# Access Compliance Report

## Public Rights-of-Way

### (Curb Ramps)

Intersection ID: N/A	Main Street: COZEN_WY	Cross Street: ROTHMAN_LN	Location: SE
ADA ID: 580237F763F1	Ramp Type: Combination1Diag	Initial Pass/Fail: Fail	Overall Compliance: No
		Severity Score: 0

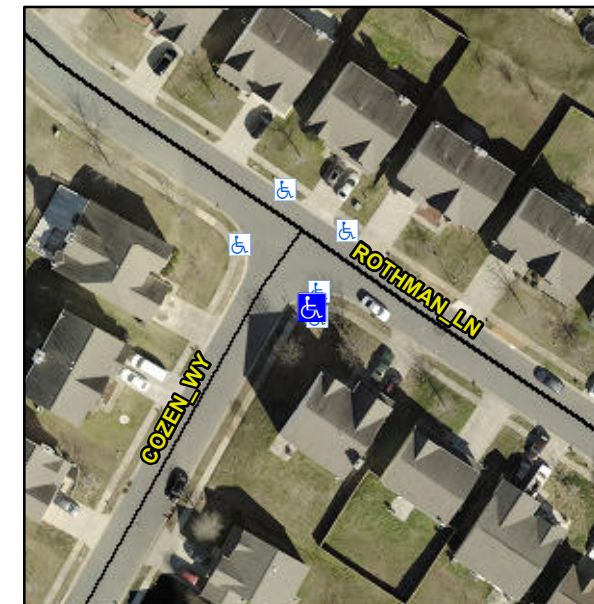
**Not Found, R304.5.1, R304.5.1, R304.2.2, R304.5.3, R304.3.2**

Compliance	Description	Data	Compliance	Description	Data
N/A	Ramp Length LT (in)	37.0	N/A	Ramp Length RT (in)	55.5
No	Ramp Width LT (in)	46.0	No	Ramp Width RT (in)	47.0
No	Ramp Slope LT (%)	10.2	Yes	Ramp Slope RT (%)	7.5
No	Ramp XSlope LT (%)	3.8	Yes	Ramp XSlope RT (%)	1.5
N/A	Ramp Length (in)	47.5	No	Ramp Slope (%)	9.8
No	Ramp Width (in)	46.5	No	Ramp XSlope (%)	6.9
N/A	Flare Type LT	N/A	N/A	Flare Type RT	N/A
N/A	Flare Slope LT (%)	N/A	N/A	Flare Slope RT (%)	N/A
N/A	Flare Traversable LT?	N/A	N/A	Flare Traversable RT?	N/A
N/A	Landing Length (in)	N/A	N/A	DWS Provided?	N/A
N/A	Landing Width (in)	N/A	N/A	DWS Contrast?	N/A
N/A	Landing Slope (%)	N/A	N/A	DWS Length (in)	N/A
N/A	Landing X Slope (%)	N/A	N/A	DWS Full Width?	N/A
N/A	Landing Curb? (Y/N)	N/A	N/A	DWS Offset (in)	N/A
N/A	Shared Landing?	N/A			
N/A	Gutter Ponding?	N/A	N/A	Gutter Slope (%)	N/A
N/A	Gutter Lip Ht (in)	N/A	N/A	Gutter X Slope (%)	N/A
N/A	Painted X Walk1?	No	N/A	Painted X Walk2?	No

**Remove & Replace Curb Ramp With Two New Directional Ramps or Equivalent.**
